Reference: U.S. Oil Sands (USOS) PR Spring Mine Response to Initial Review – List of Pages

Re: **M/047/0090 - U.S. Oil Sands, Inc., PR Spring Mine – Response to Initial Review of Revised Notice of Intention (NOI) to Commence Large Mining Operations**

**Response to INITIAL REVIEW OF NOTICE OF INTENTION
TO COMMENCE LARGE MINING OPERATIONS**

**U.S. Oil Sands
PR Spring Mine**

Title: **Erosion Control Structures**

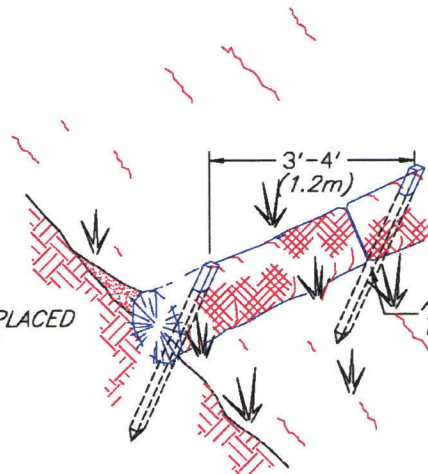
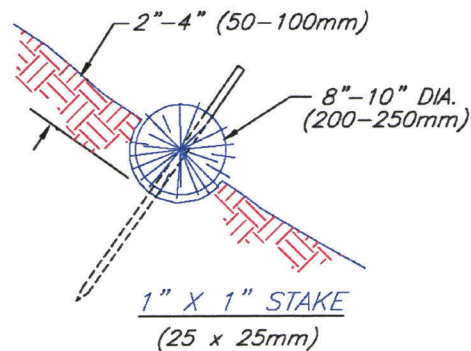
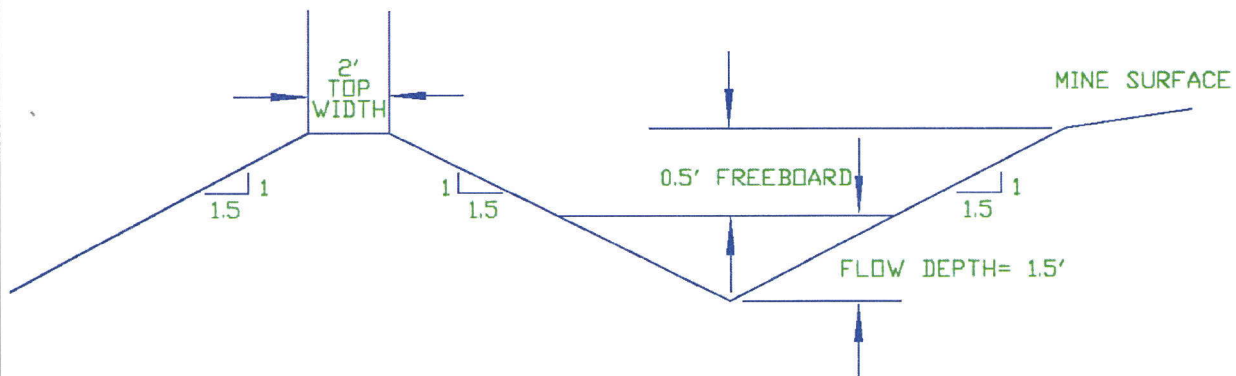
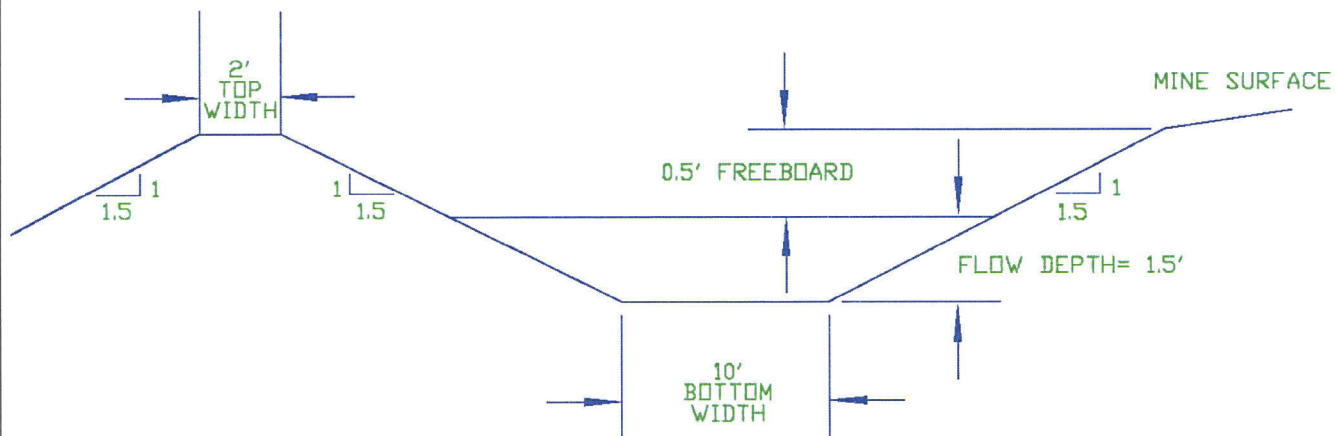
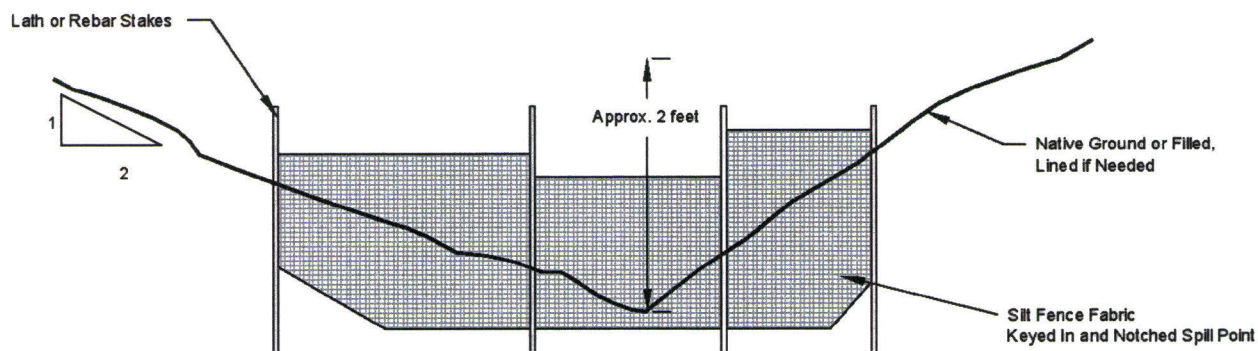
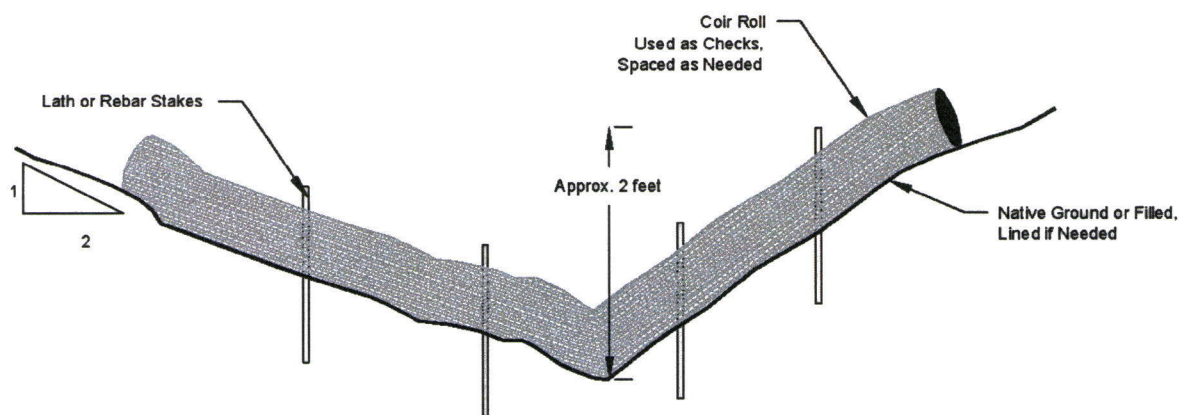
Com ment #	Sheet/Page/ Map/Table #	Comments	Initia ls	Revie w Actio n
6	All X-sections	On Figures 6a, 6b and 6c, please label the slope angles on both the cut and the fill slopes to be consistent with the text. The rock slopes discussed on page 10 commit to 1H:1V slope, so please label x-sections as “max 1H:1V”. Fill slopes noted on page 15 to be no steeper than 3H:1V, so please label x-sections as “max 3H:1V”. <i>On Figures 6a and 6b, the slope angles have been labeled as suggested.</i>	lah	
7	Omission	Please add a figure or plan sheet of “typical BMP’s” for erosion control. The BMP design drawings from the original Notice were omitted for this submission. The Division would like to have the BMP erosion control structures resubmitted so these structures match the ones that will be used onsite. <i>BMP drawings are being provided in Appendix G. Also see comment #12</i>	lah aa
